re: Draft EIR, Three Creeks Trail Pedestrian Bridge Project, File No. PP13-085

I would like to submit the following questions and comments regarding the Draft Environmental Impact Report (DEIR) on the Three Creeks Trail Pedestrian Bridge Project (File No. PP13-085), which details the plans for the demolition of the 1922 Western Pacific Railroad Trestle across the Los Gatos Creek in Willow Glen (called the “Los Gatos Creek Trestle” in the DEIR and what we call the “Willow Glen Trestle”), and the installation in its place of a new prefabricated single-span truss steel bicycle/pedestrian bridge (the “prefab steel bridge”).

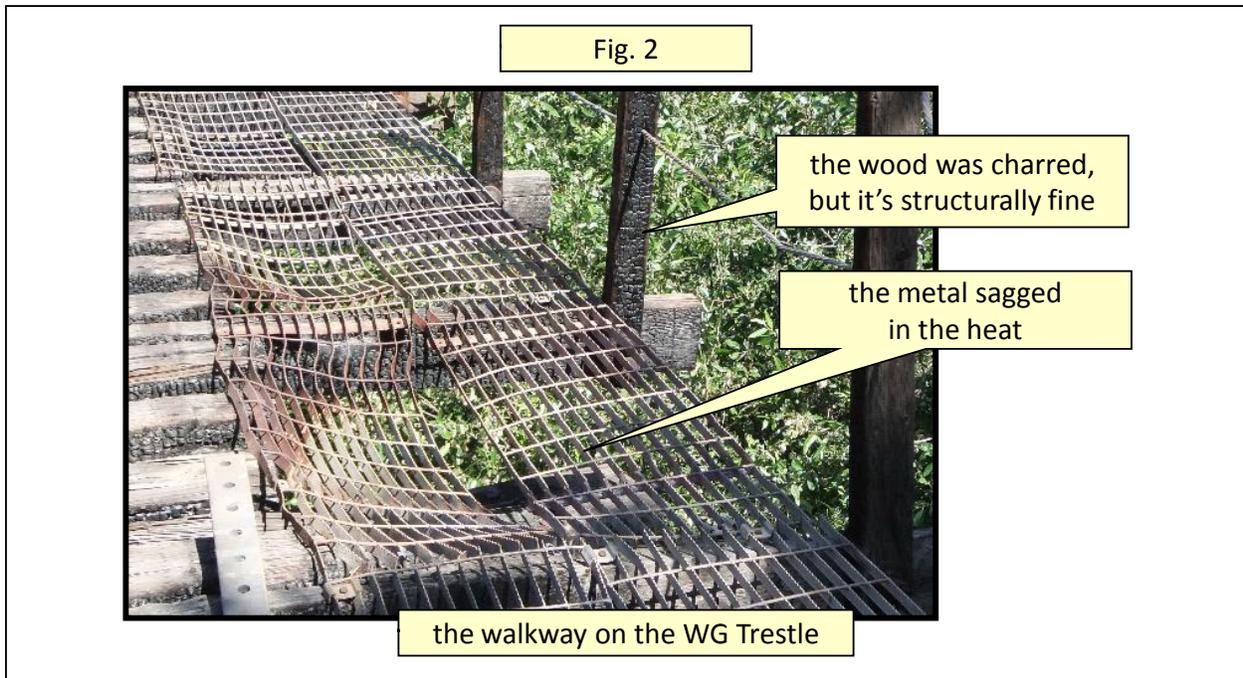
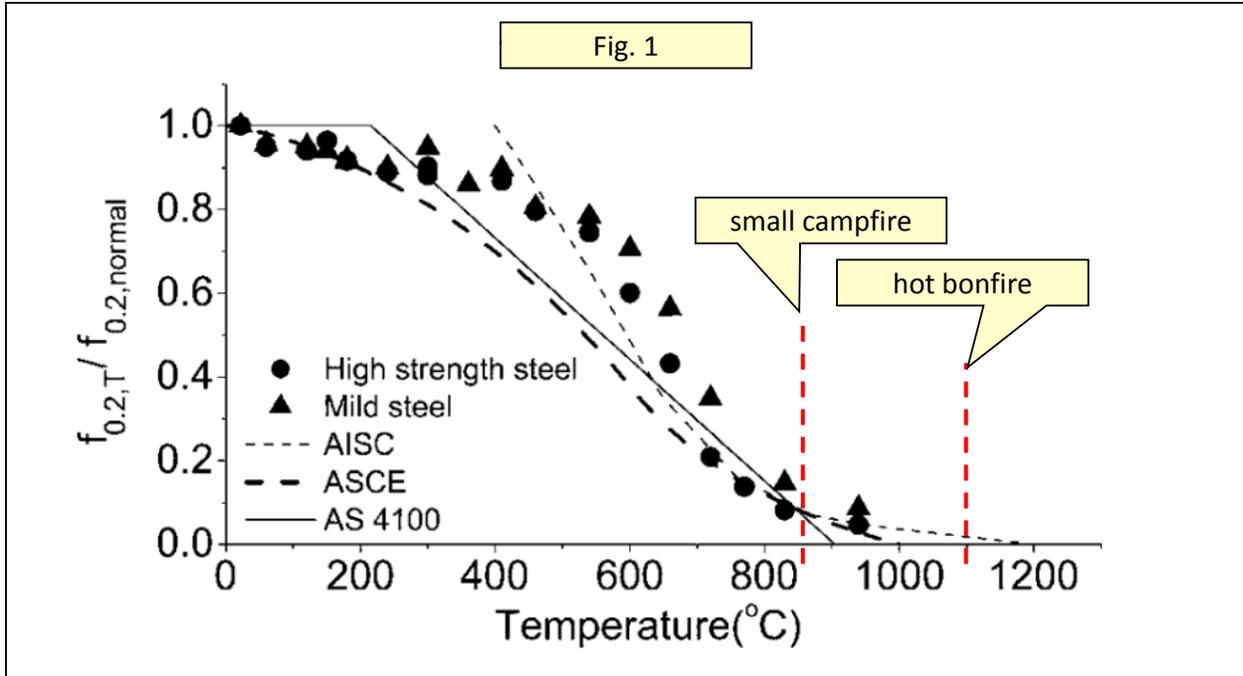
Fire does affect steel: when it gets above about 1,100 deg. F (600° C), it loses half its strength, and at 1,500° F (850° C – the temperature of a small campfire) it’s only a tenth as strong. A fire in a nearby clump of the invasive giant reed (*Arundo donax*, sometimes referred to as “bamboo”) could exceed 2,000° F (1,100° C), and the entire single-span bridge could collapse if any portion of the truss is compromised – which might require more than a “short-term closure” to repair.

This is not very esoteric knowledge: it can quickly be found with an internet search. For example, my Fig. 1 here is adapted from data found in a paper entitled “Behavior of high strength structural steel at elevated temperatures”, online at <http://ro.uow.edu.au/cgi/viewcontent.cgi?article=1345&context=engpapers>. It is information known to architects (I remember an architect explaining this to me decades ago) and to firefighters (I’m told that they have to have their ladders recertified if exposed to flames). Figure 2 is a real-world example: the metal walkway on the Willow Glen Trestle sagged in the heat of a past brush-fire, while the supporting wood timbers are charred but still strong.

Wood burns and steel doesn’t, but, as indicated by Fig. 1 and 2 above, steel can “yield” when excessively heated. The metal does not melt, but it does lose its strength, resulting in structures “buckling” (or “crumpling”, “sagging”, ...). This gives rise to a group of questions that need to be addressed by the DEIR:

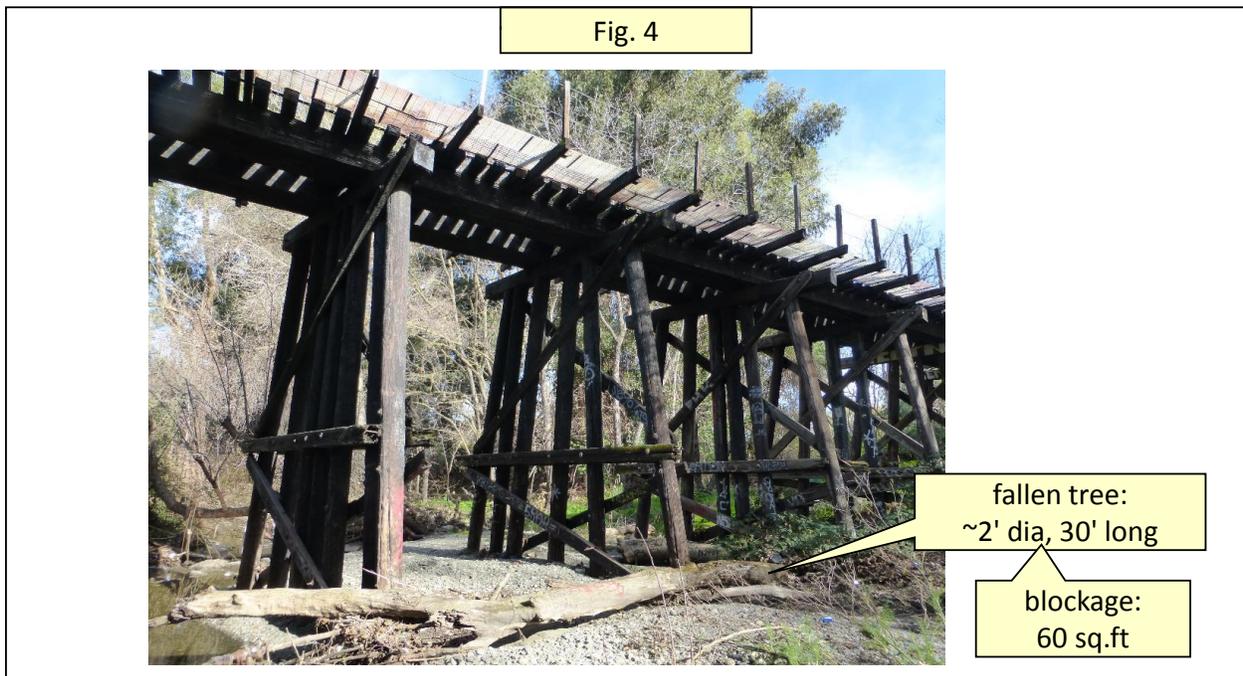
- The elevation of the top-of-bank and the bottom of the channel are shown in DEIR Fig. 2-1 in §2.4 (page 25 of the DEIR PDF): the top has an elevation of over 119 feet, and the bottom is at 94.3 feet.

By combining these pieces of information from various locations within the DEIR, one can learn that the creek channel is 25' deep, and the 100-year flood waters are more than 10' below the top-of-bank: it is not a flood hazard. As summarized on DEIR page 3-48 (p. 78 in the PDF), “**hydraulic changes and flooding upstream or downstream of the project site would be less than significant.**” [Emphasis in the original.]

It would be quite helpful for the decision-makers if all this information were to be collected into a single graphic, perhaps by annotating DEIR Fig. 2.1 as shown here in Fig. 3:

Fig. 9

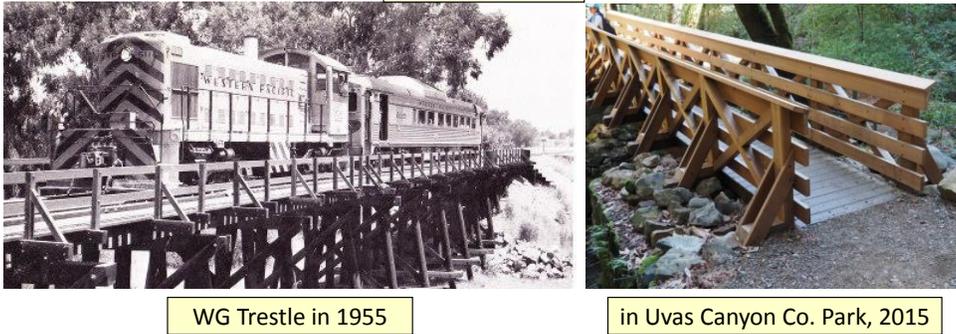
In the DEIR, Figure 6-1 shows a rendering of a possible retrofit: the drawing is devoid of all soul. Fortunately, as noted on p. 6-1 (PDF p. 97), *“If bridge retrofit is selected as the preferred alternative, then additional refinements could be made.”* Figure 9 (below) shows what the Willow Glen Trestle looked like in 1955. Next to it is a pedestrian bridge recently built in Uvas Canyon County Park: sturdy, environmentally responsible, and quite reminiscent of the trestle in 1955. Hopefully, the trestle will be saved, and the community can consider a variety of such design options.
